AES-O-NRC-13-02687

AREVA Enrichment Services LLC  
Eagle Rock Enrichment Facility  
NRC Docket No. 70-7015

Subject: License Amendment Request (LAR) 13-02, Request to Modify Materials License SNM-2015, License Condition #10

### Proposed Revised Pages of Safety Analysis Report

**Figure ~~6.4-4~~, Effluent Release Points and Meteorological Tower, contains Security-Related Information Withheld from Disclosure under 10 CFR 2.390**

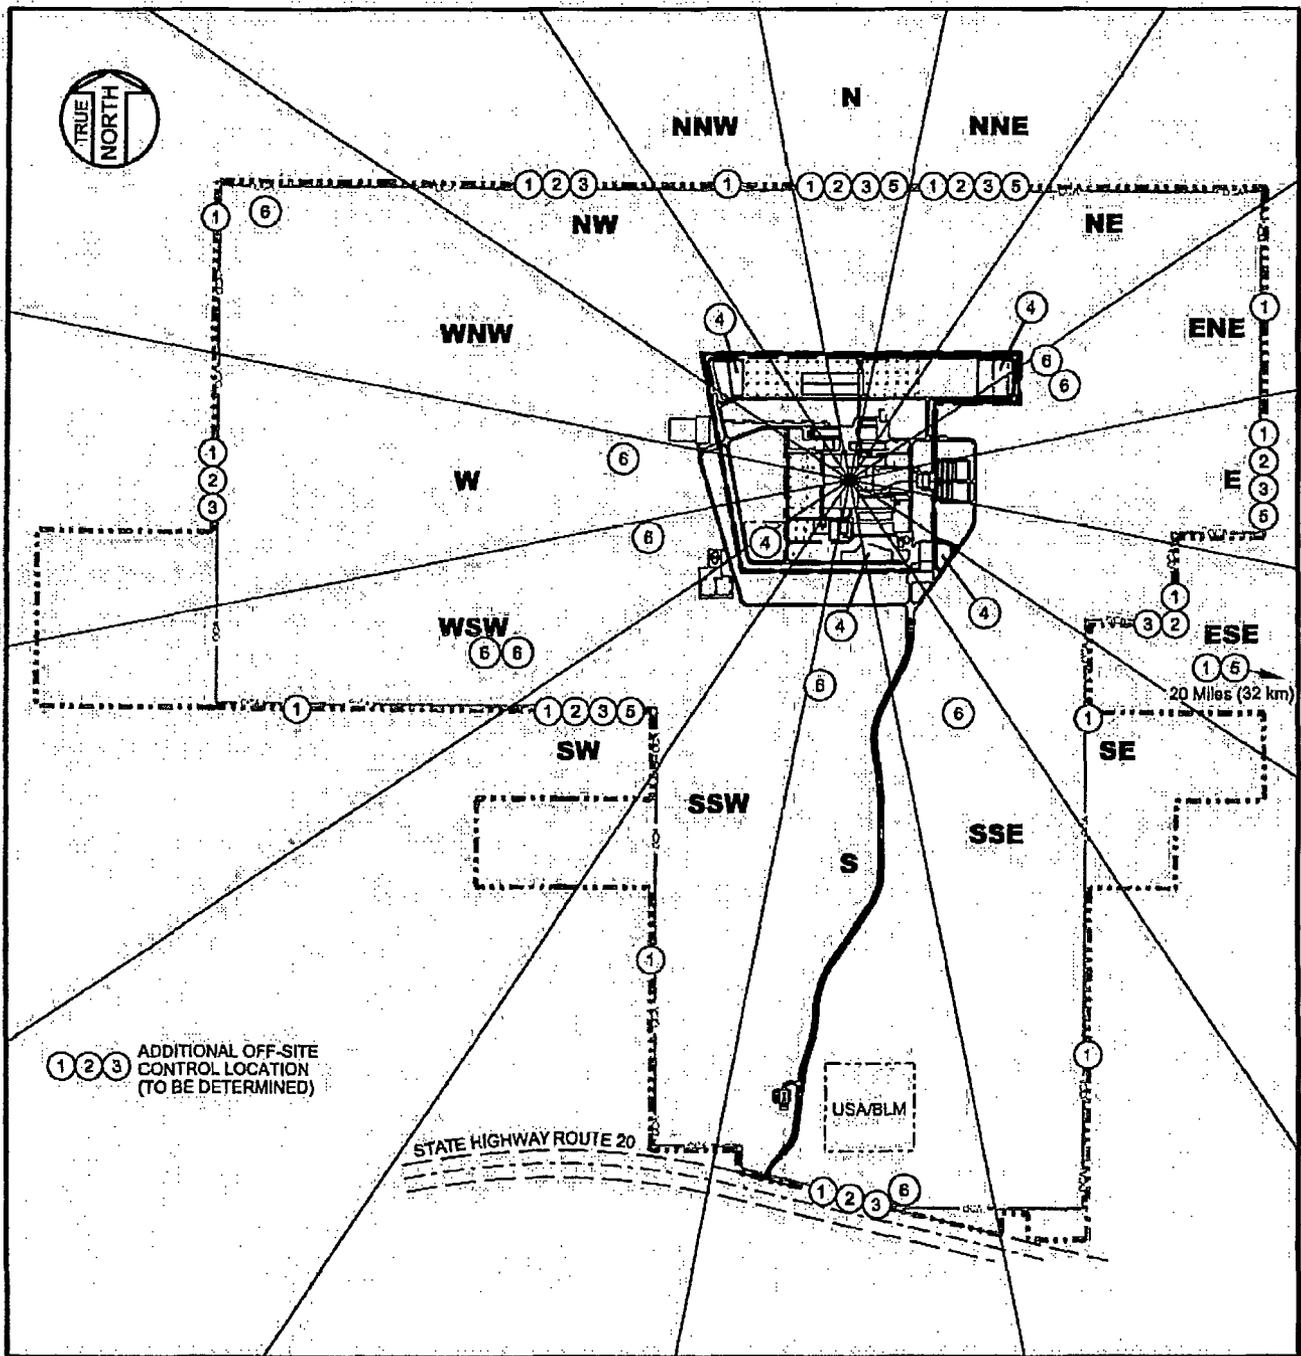
[Figure 9.2-1, Effluent Release Points and Meteorological Tower, indicates the locations of air and liquid effluent release points from the facility complex to the environment. Effluents will be sampled as indicated in Table 9.2-1, Effluent Monitoring Program. This table presents an overview of the effluent sampling program. For gaseous effluents, liquid condensate samples from the evaporator exhaust vent and continuous air sampler filters are analyzed for gross alpha and gross beta each week. The filters, or liquid condensate samples, are composited quarterly and an isotopic analysis is performed if a specified gross alpha or gross beta action level is exceeded (as specified in Table 9.2-1).] [Table 9.2-2, Required Lower Limit of Detection for Effluent Sample Analysis, summarizes detection requirements for gaseous effluent sample analyses.] [Sampling of liquid effluent discharges to the detention and retention basins are described below in Section 9.2.2.2, Environmental Monitoring.]

Figure 9.2-1, Effluent Release Points and Meteorological Tower, indicates the locations of air and liquid effluent release points from the facility complex to the environment. Effluents will be sampled as indicated in Table 9.2-1, Effluent Monitoring Program. This table presents an overview of the effluent sampling program. For gaseous effluents, liquid condensate samples from the evaporator exhaust vent and continuous air sampler filters are analyzed for gross alpha and gross beta each week. The filters, or liquid condensate samples, are composited quarterly and an isotopic analysis is performed if a specified gross alpha or gross beta action level is exceeded (as specified in Table 9.2-1). Table 9.2-2, Required Lower Limit of Detection for Effluent Sample Analysis, summarizes detection requirements for gaseous effluent sample analyses. Sampling of liquid effluent discharges to the detention and retention basins are described below in Section 9.2.2.2, Environmental Monitoring.
